CITY OF OREGON CITY HISTORIC REVIEW BOARD (HRB) AGENDA

2. Recommendation of Adoption of the Design Guidelines for New Construction- Middle Housing to the City Commission
3. New Construction of a Tri-Plex on Land that is Part of a Designated Landmark - Rasmussen-Buol House (151 Molalla Avenue) (GLUA-23-00001; HR 23-00002)

**PRESERVATION GRANT REQUEST
HISTORIC REVIEW BOARD
March 20, 2023**

REVIEWER: Christina Robertson-Gardiner, AICP Senior Planner

Proposed site plan

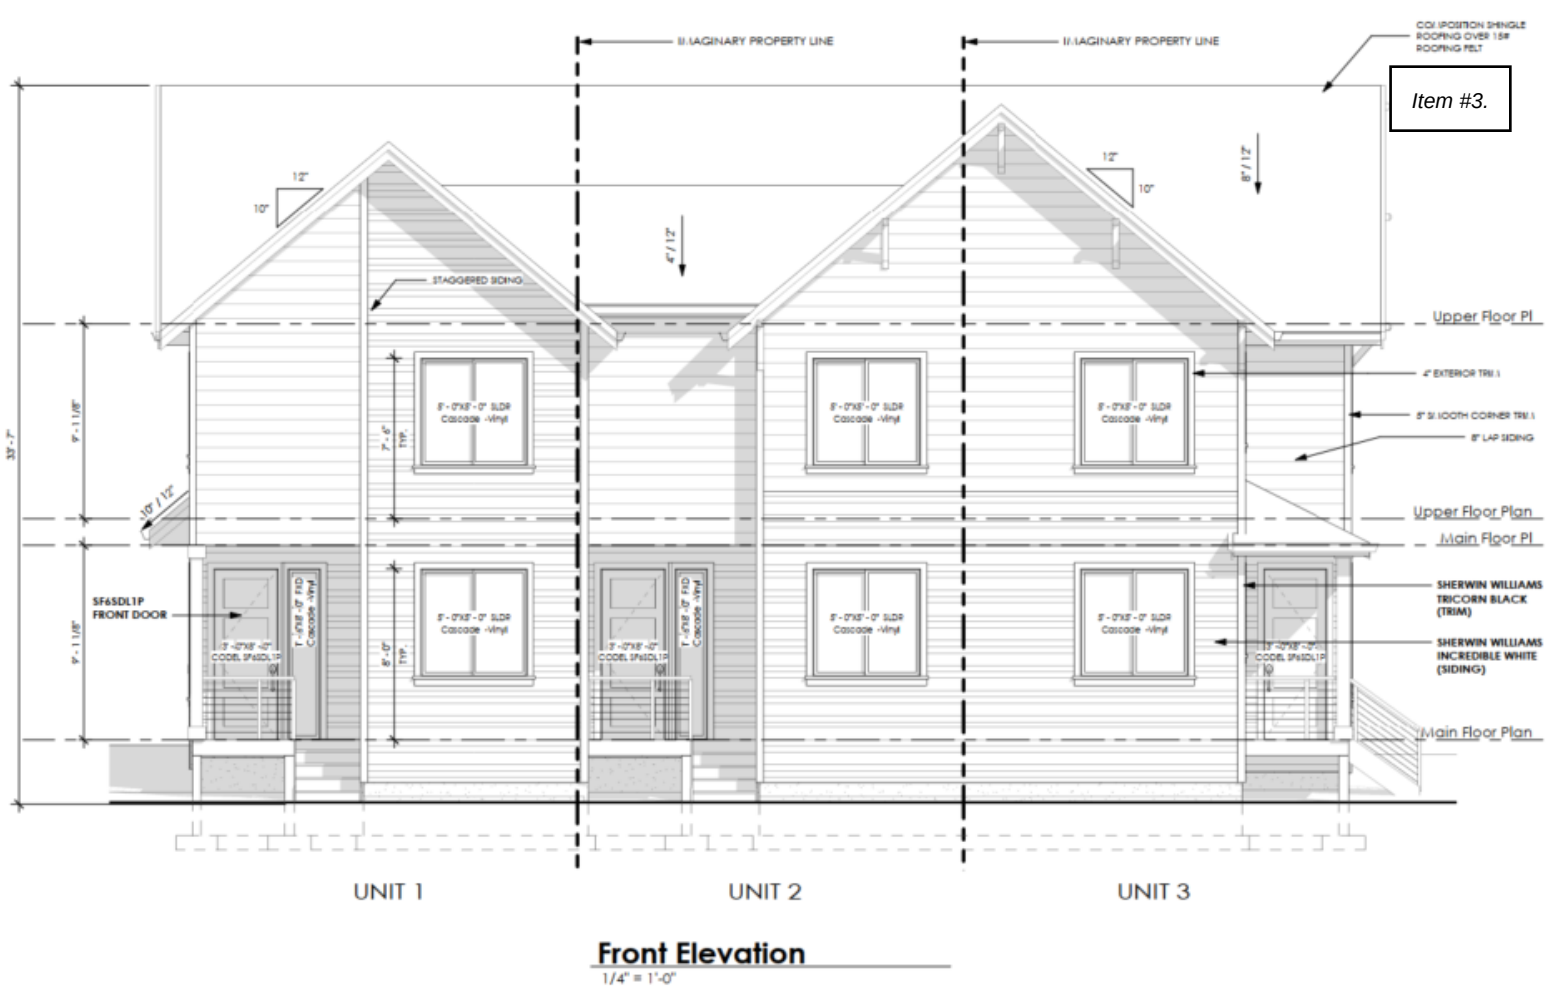
View of the proposed building next to the Landmark. (note the applicant has proposed a 19-foot setback approximately one foot deeper than the existing landmark setback of 18 feet.)

Rear Elevation

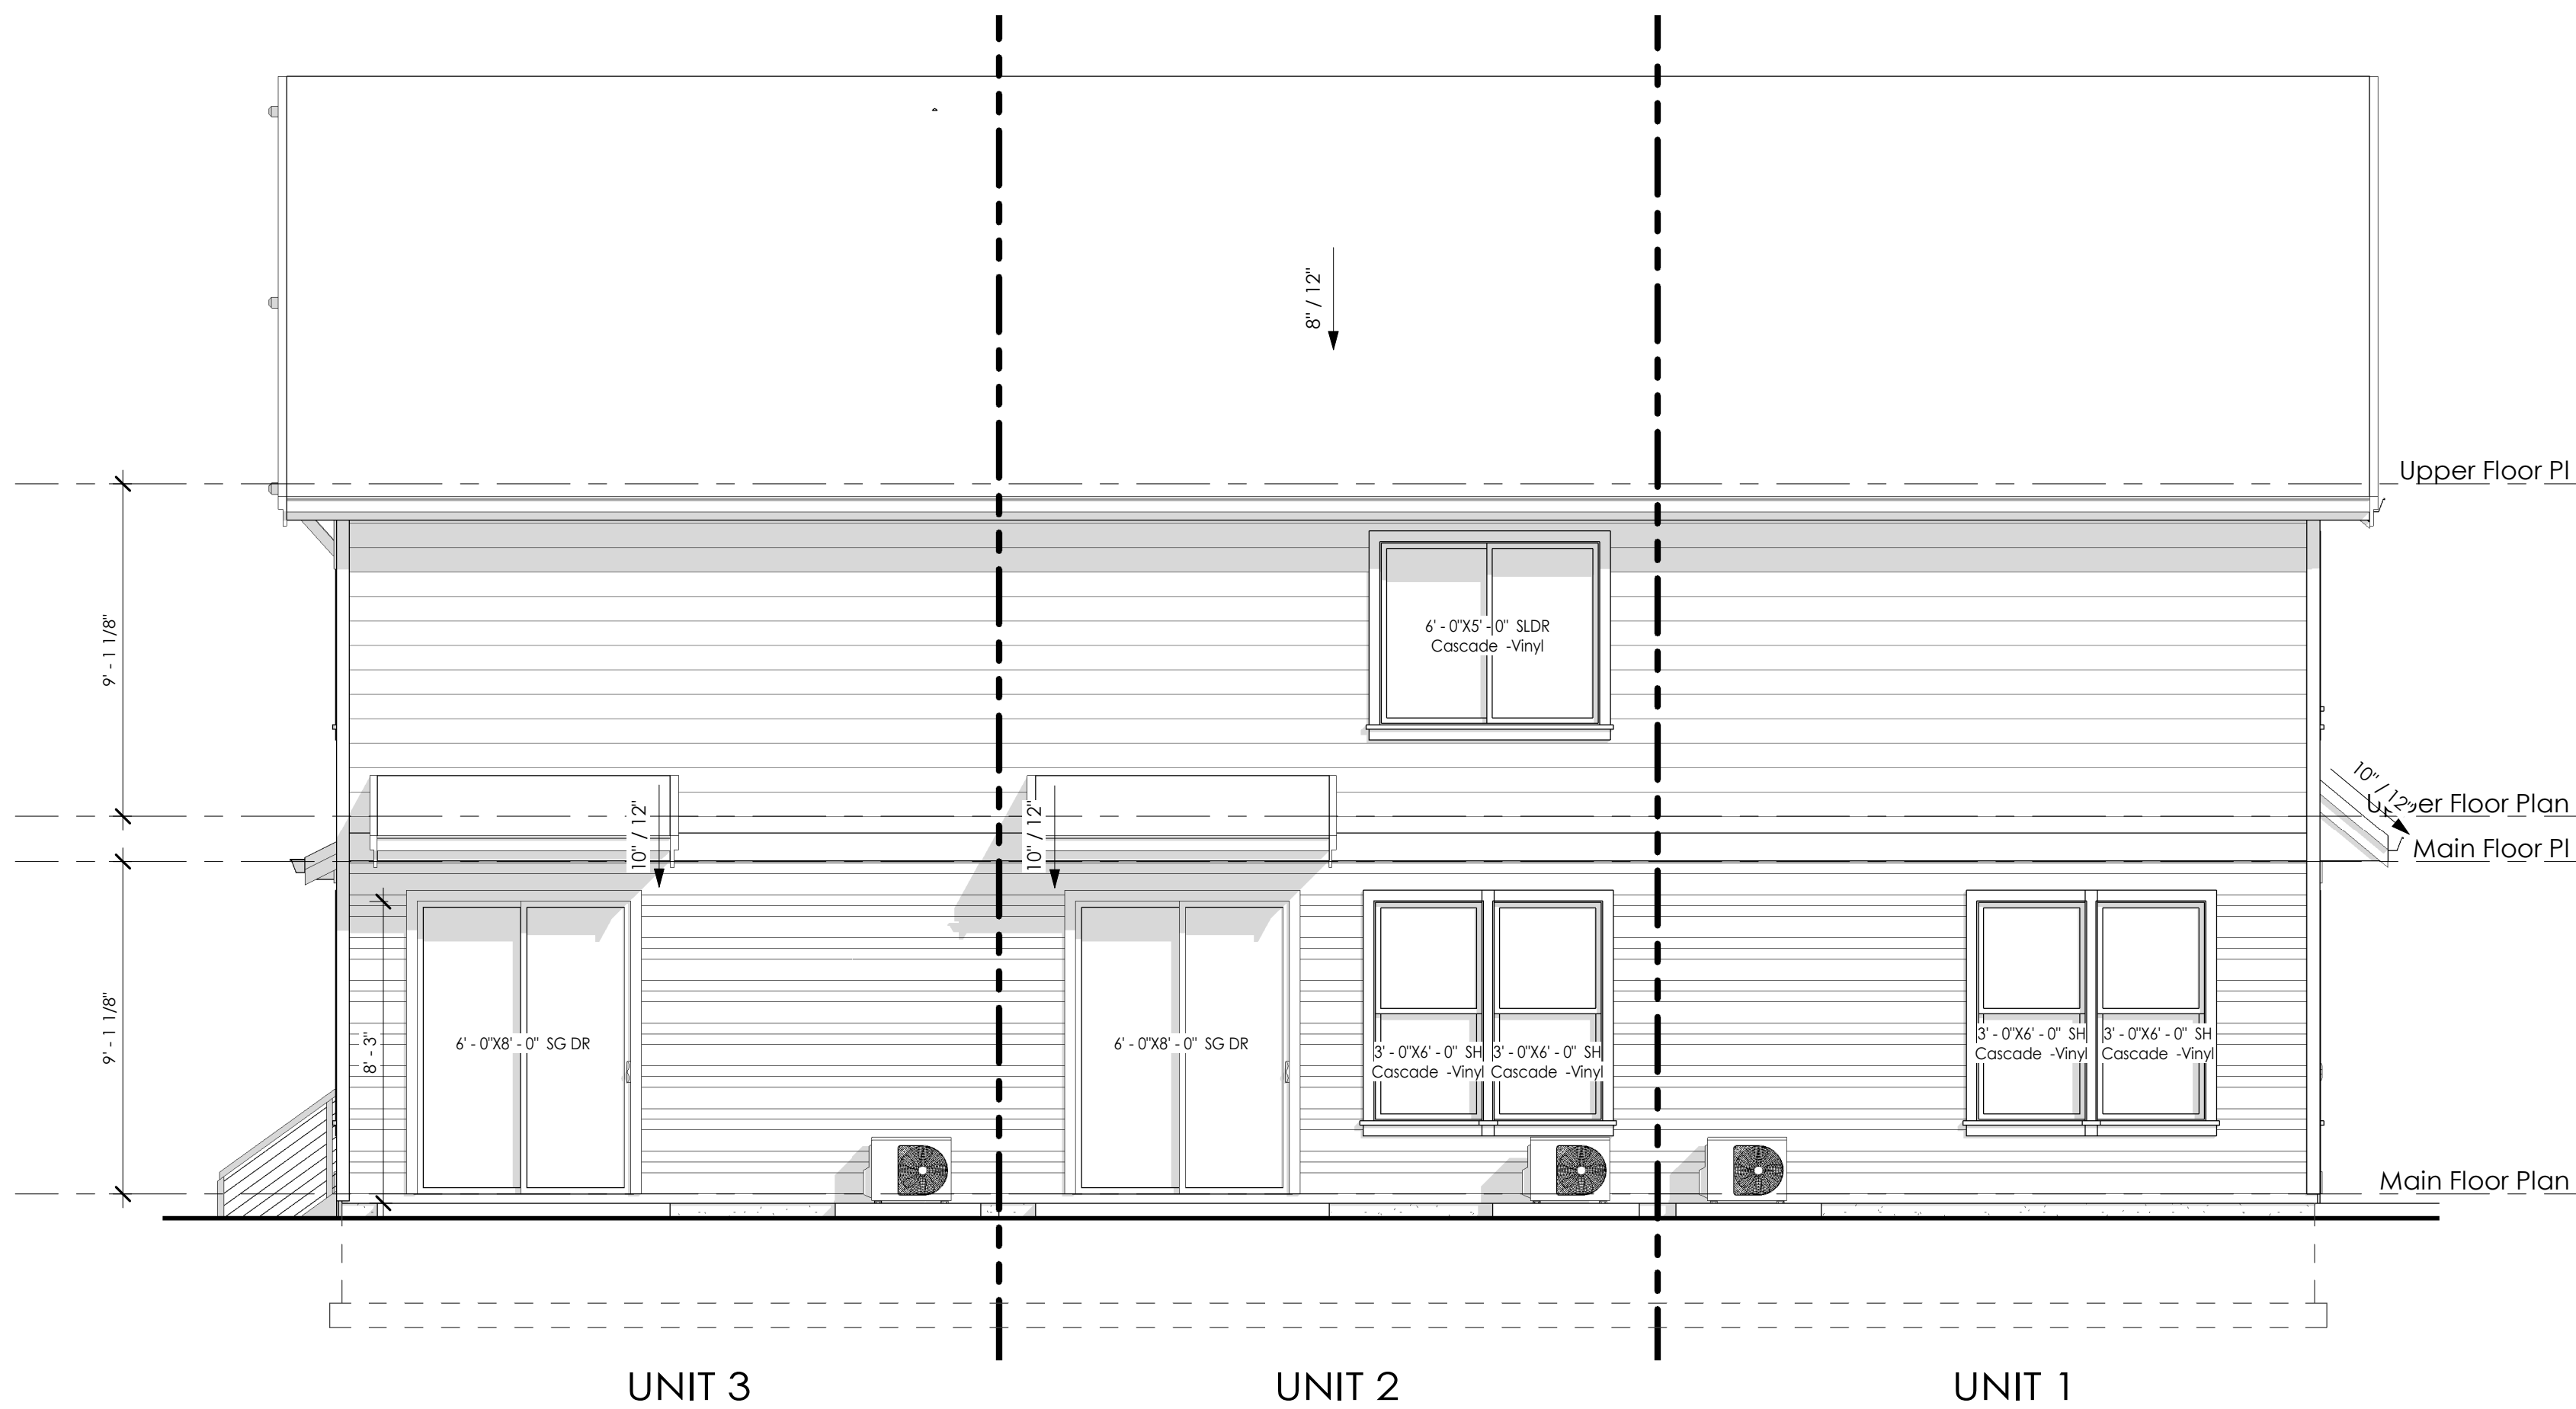
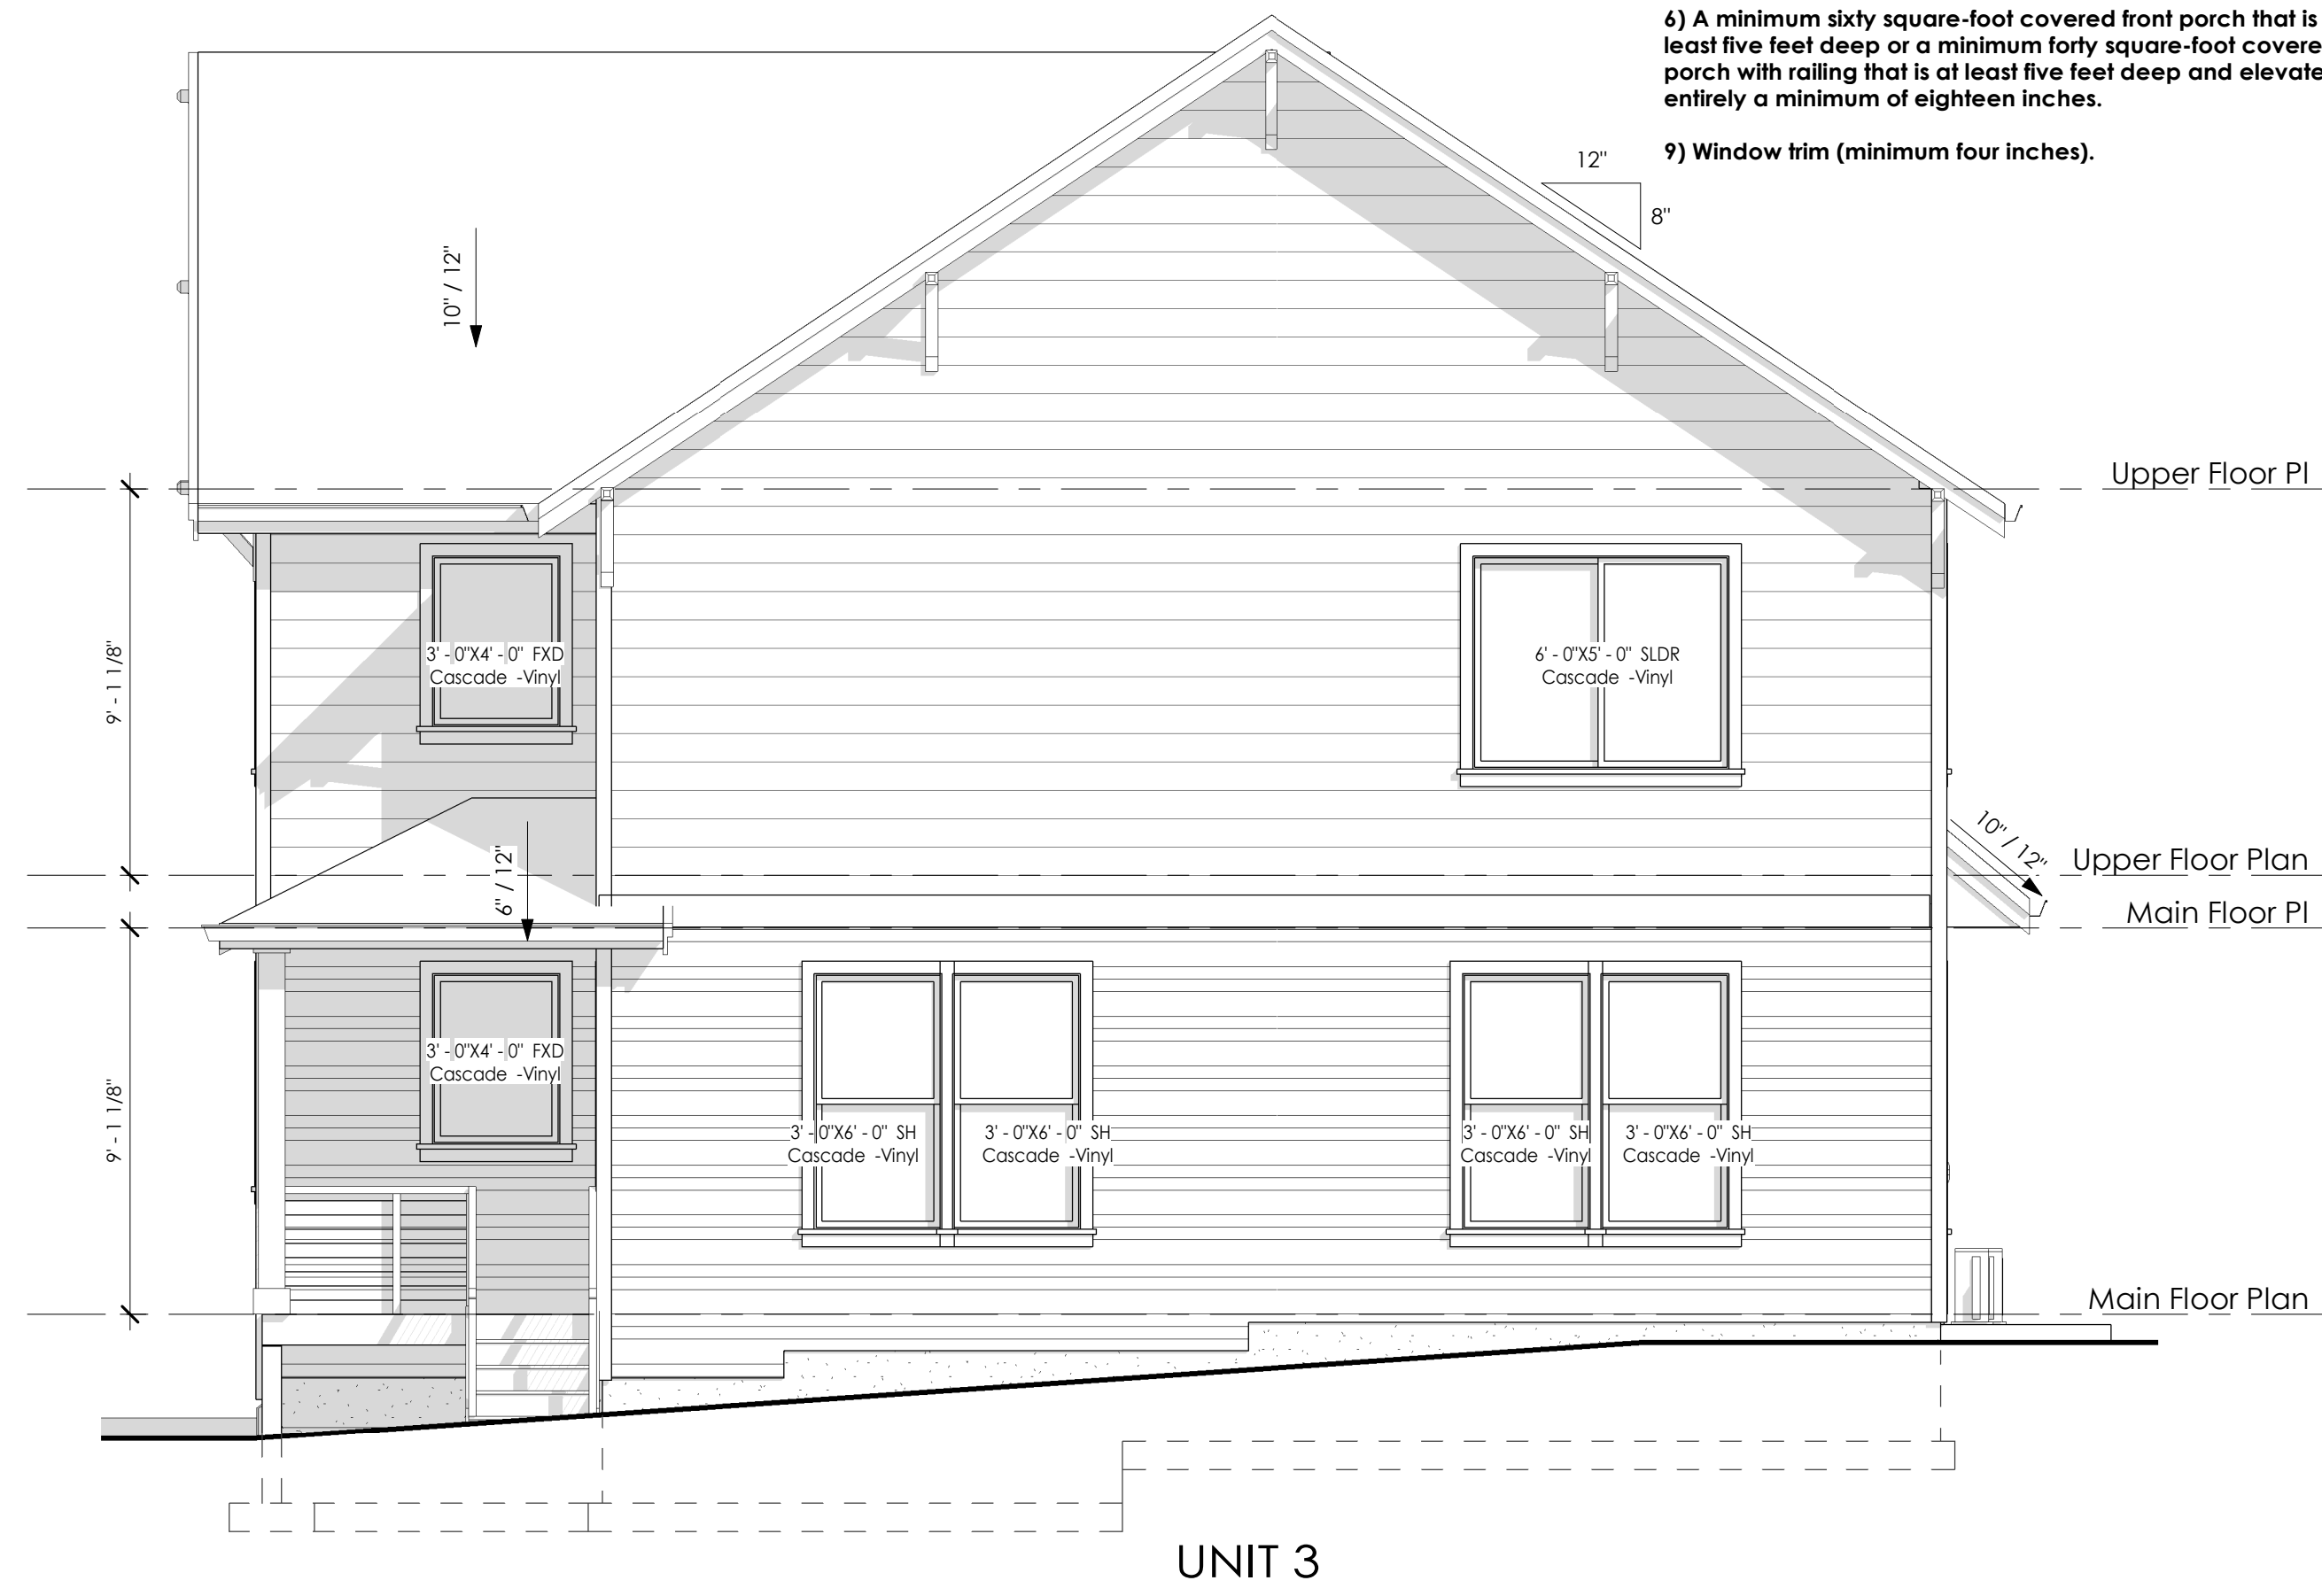
- d. The window sash shall be inset and not flush to the trim. A minimum 4-inch trim is required.
 - e. Additional and proportionally spaced windows shall be added to the rear elevation, which abuts the Landmark property.
